ADDENDUM 1

ADDENDUM DATE: April 9th, 2019

PROJECT: OCSC Expansion - Phase 1, Seymour Center
2551 Homestead Rd.
Chapel Hill, NC 27516

The following is a list of changes that have been made to the plans since the issuance of bid documents. These changes are as a result of Town review comments.

C5-30

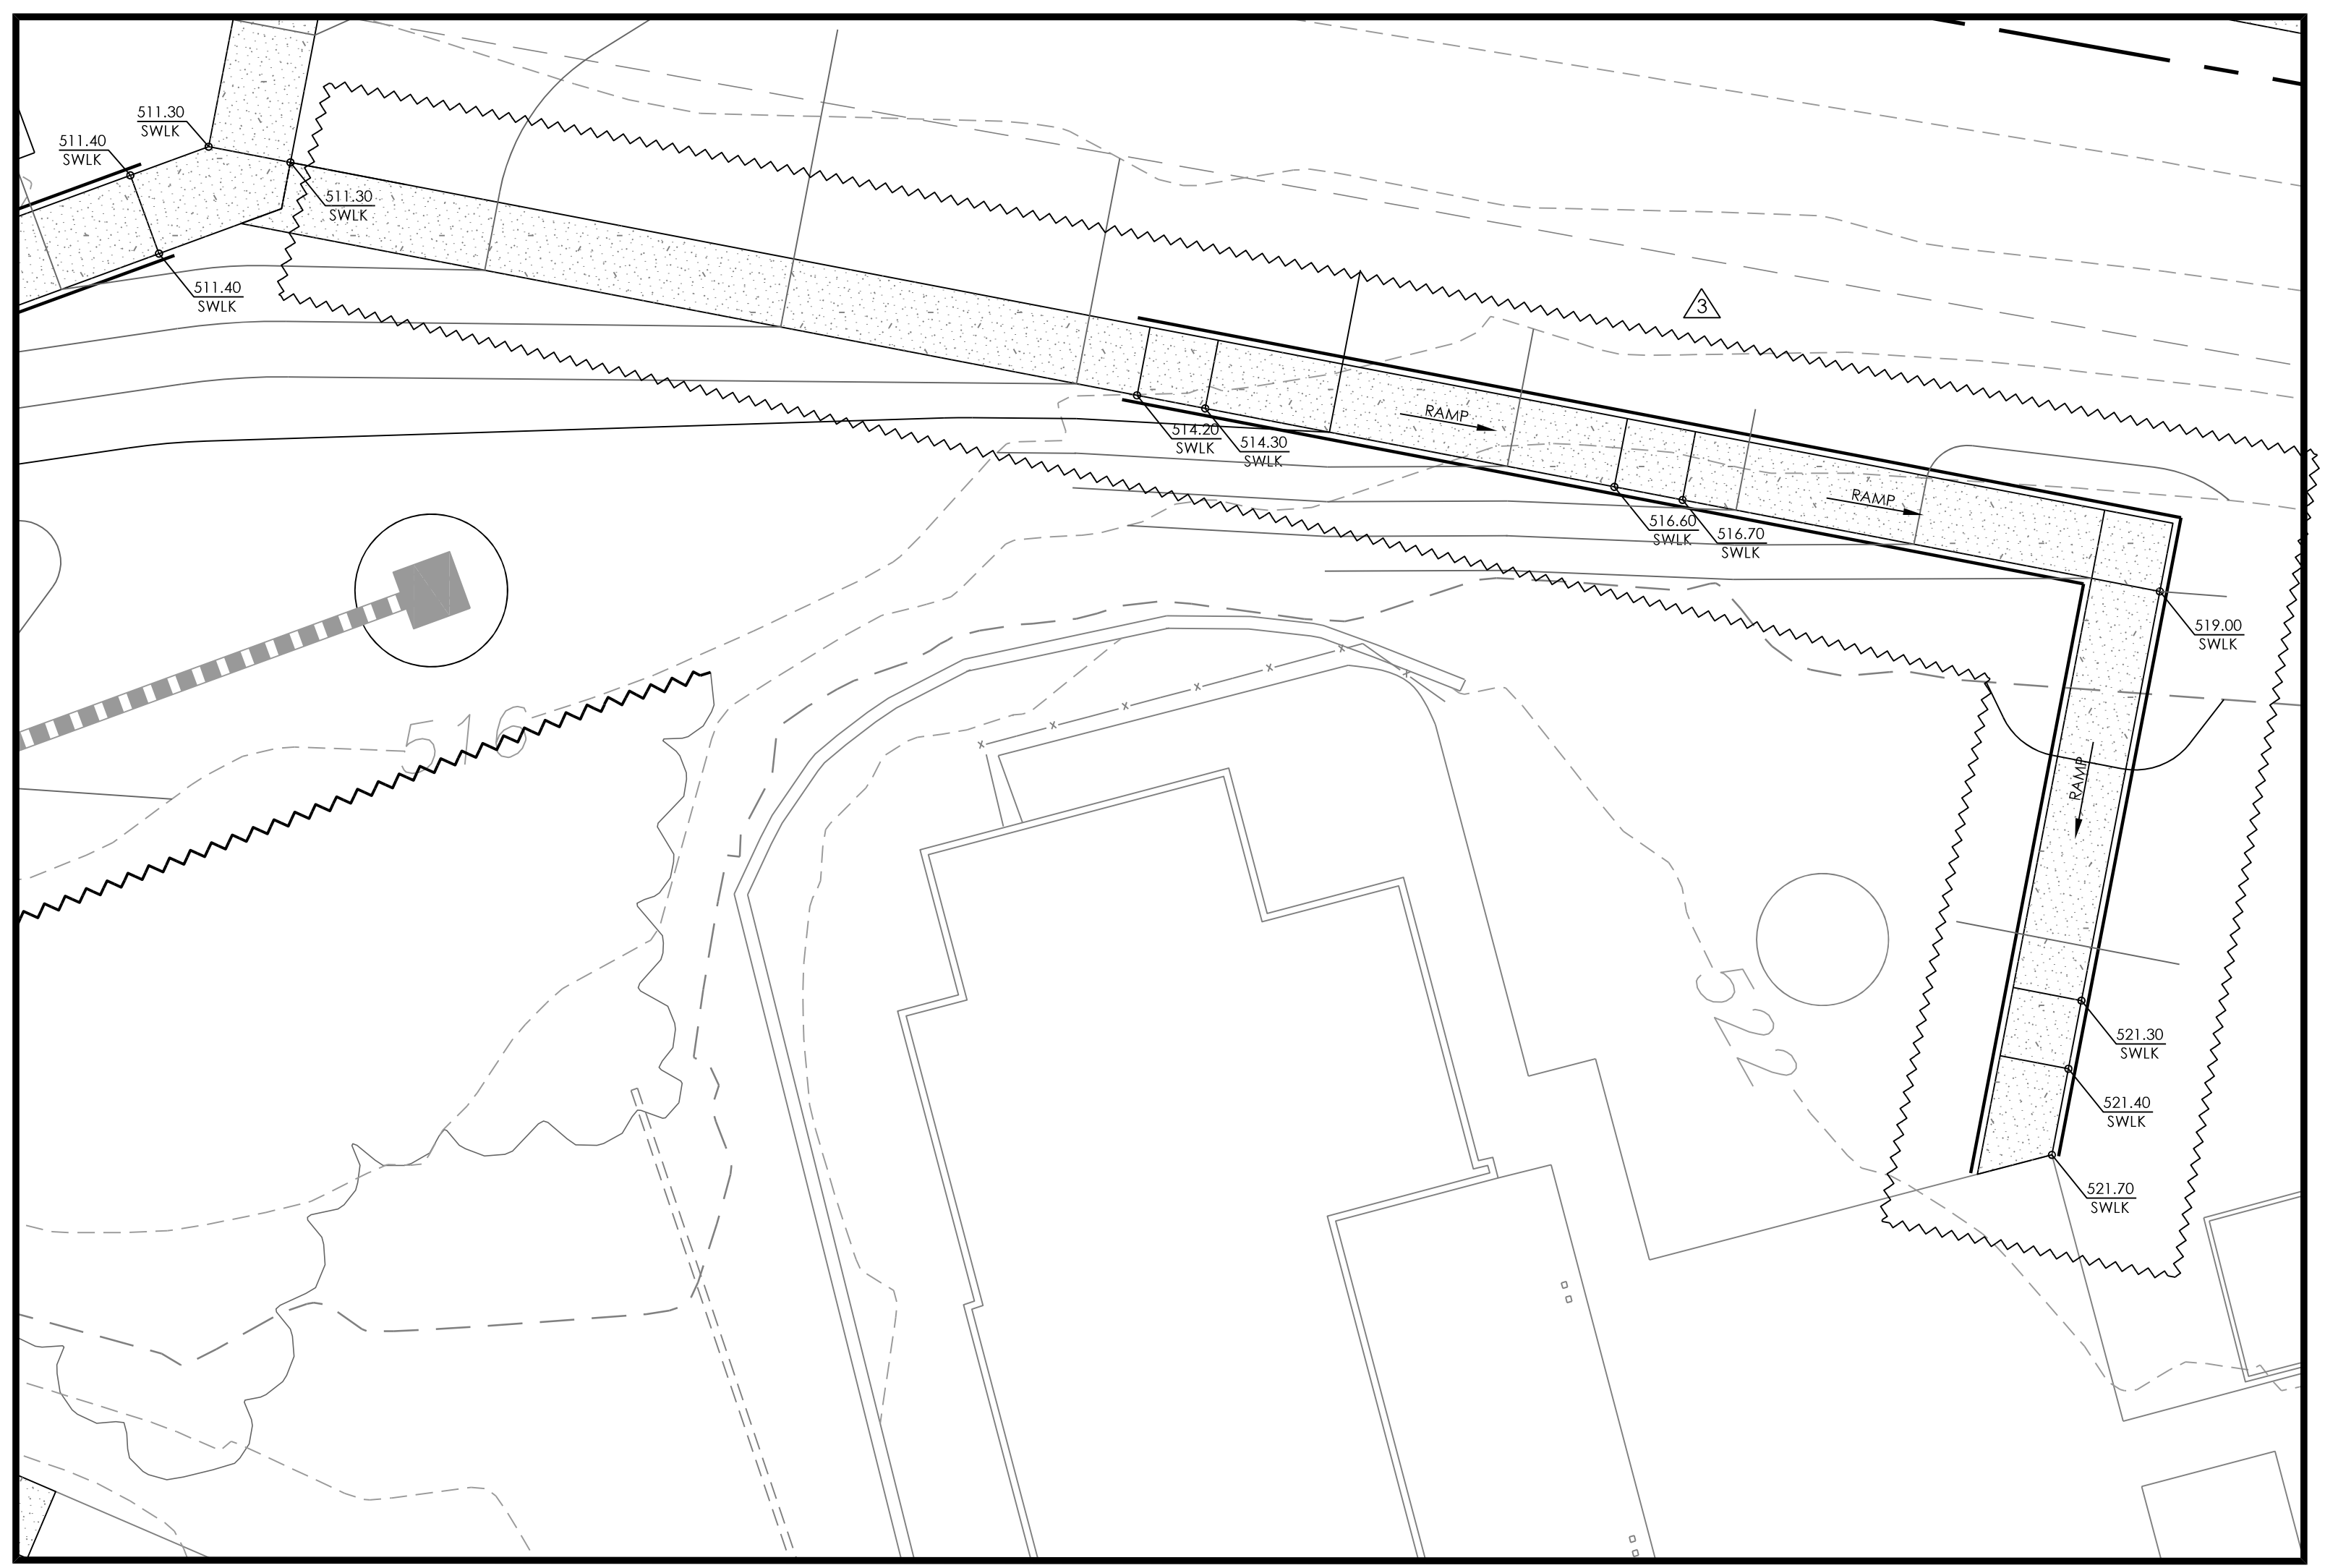
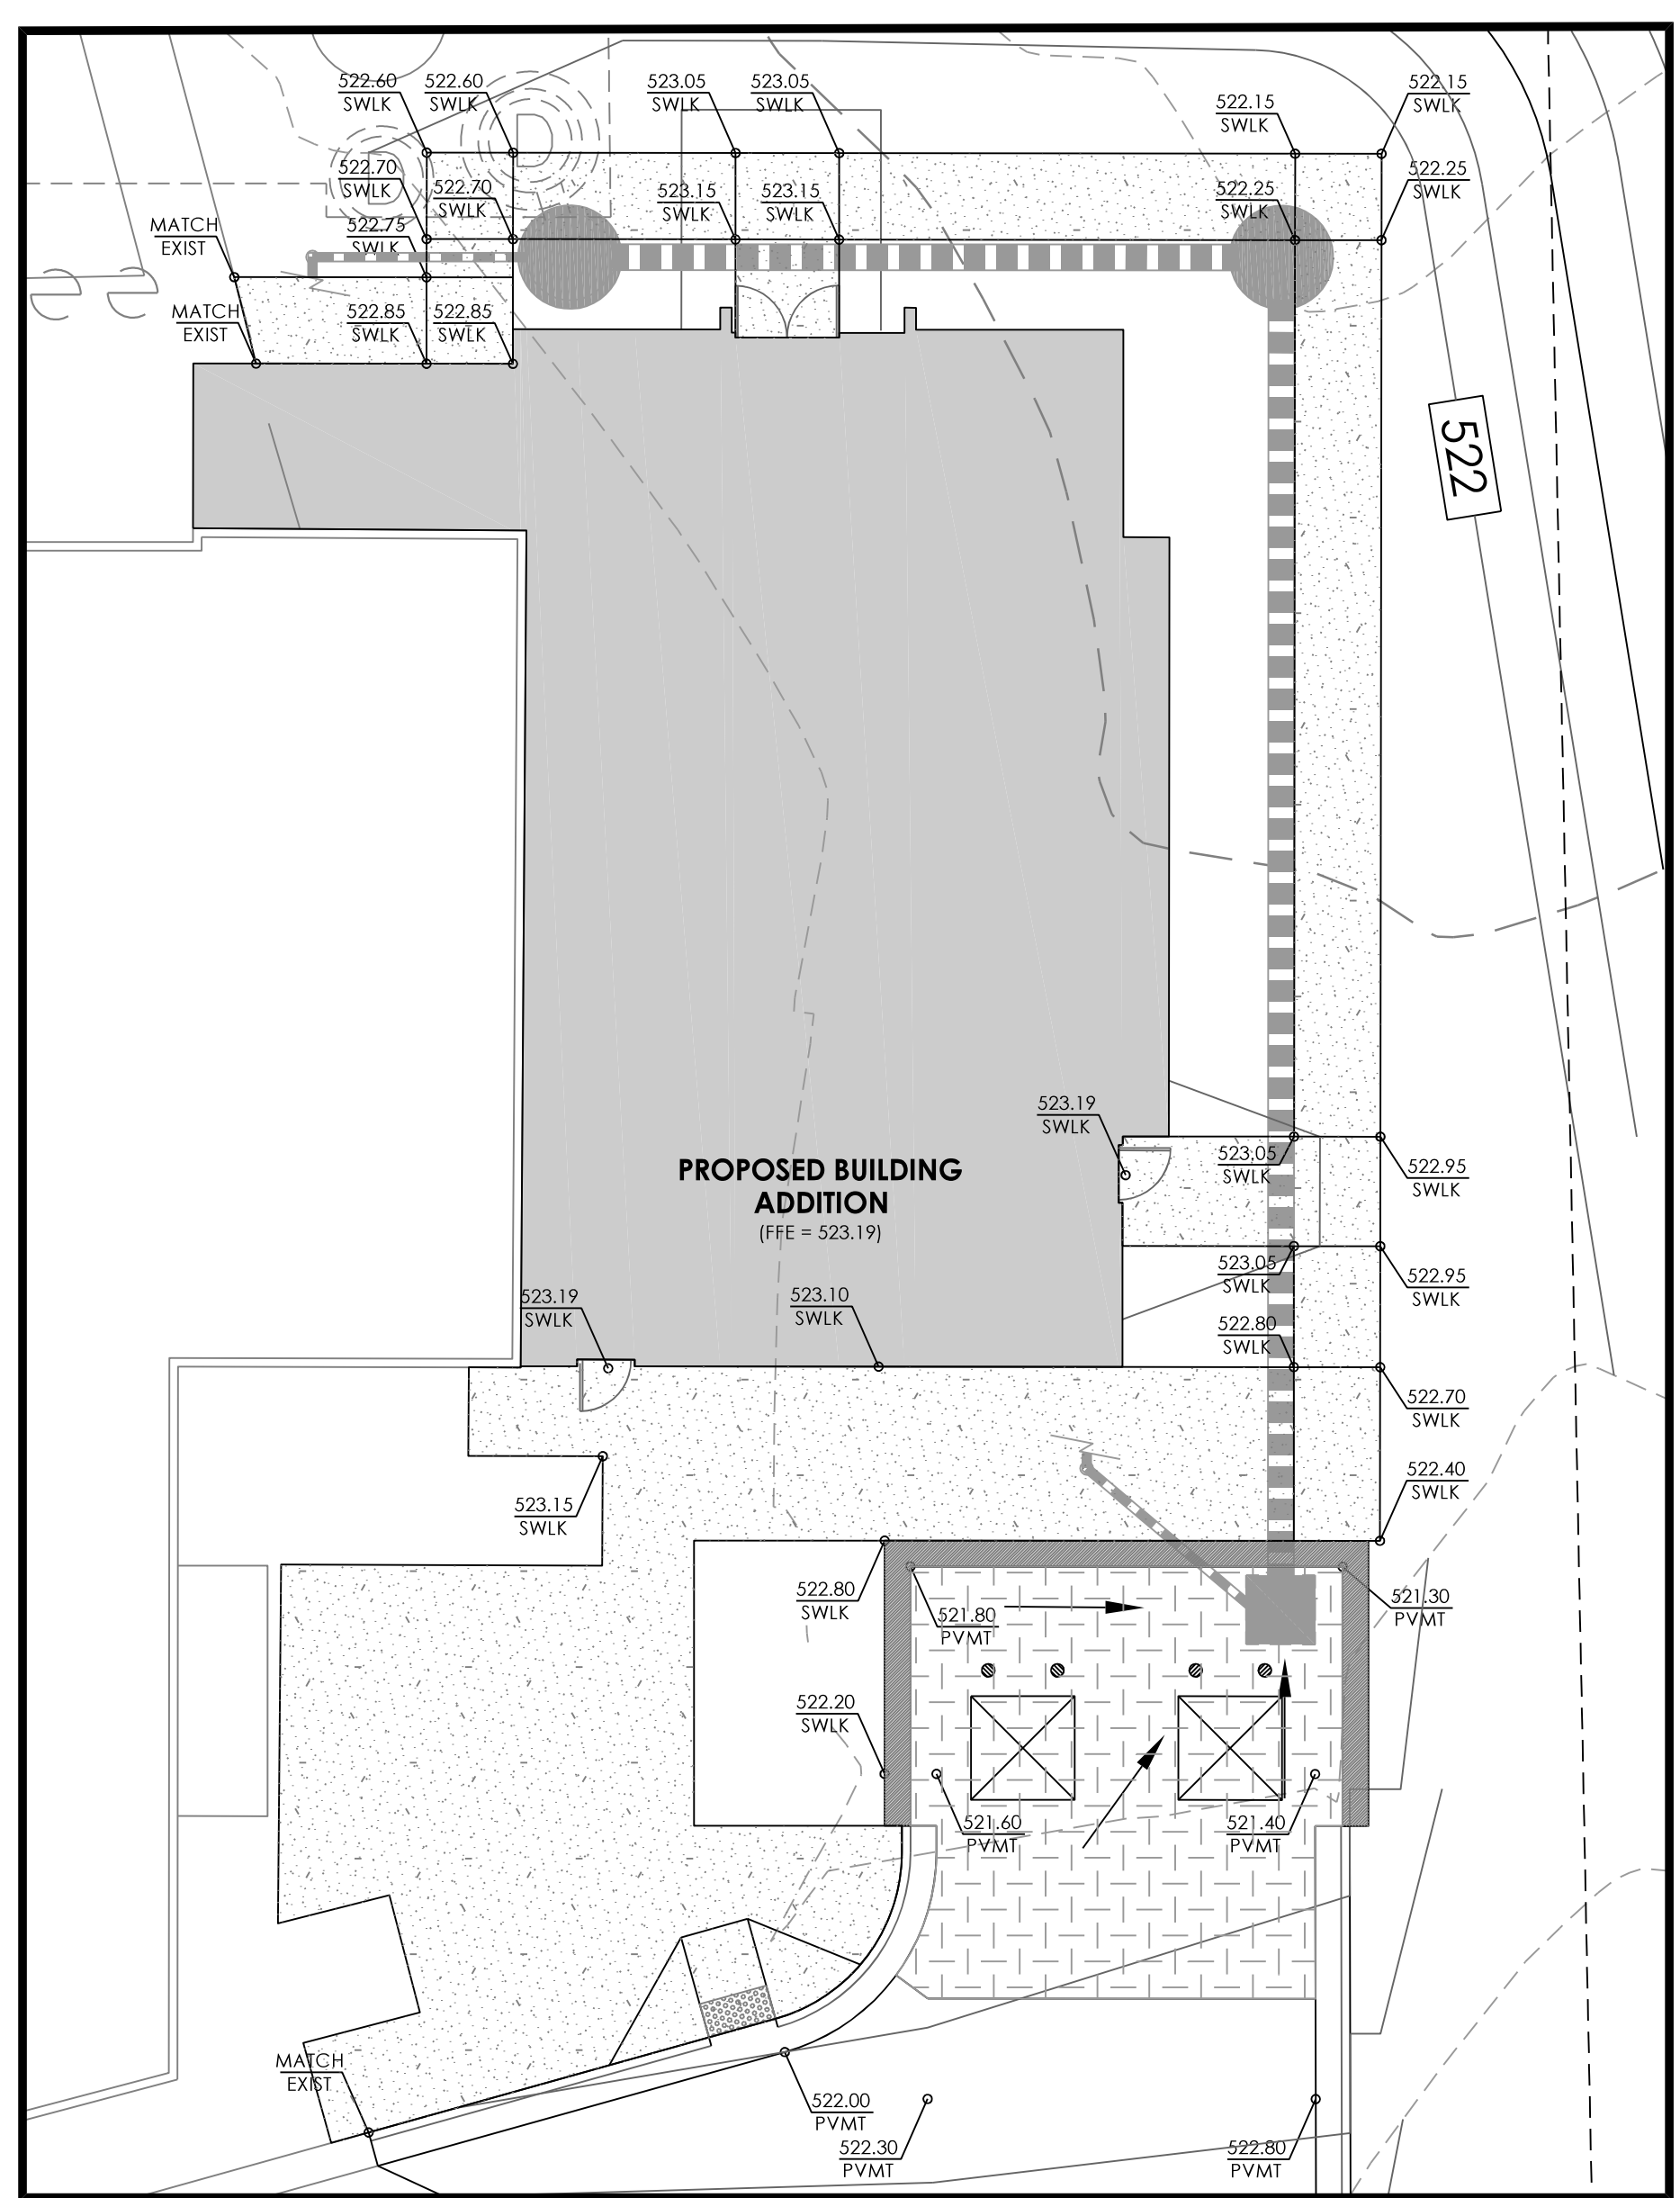
5. Several sections of the storm drainage system on site have been revised including elevations and pipe sizes. (Refer to sheets C5-30 and C8-00)
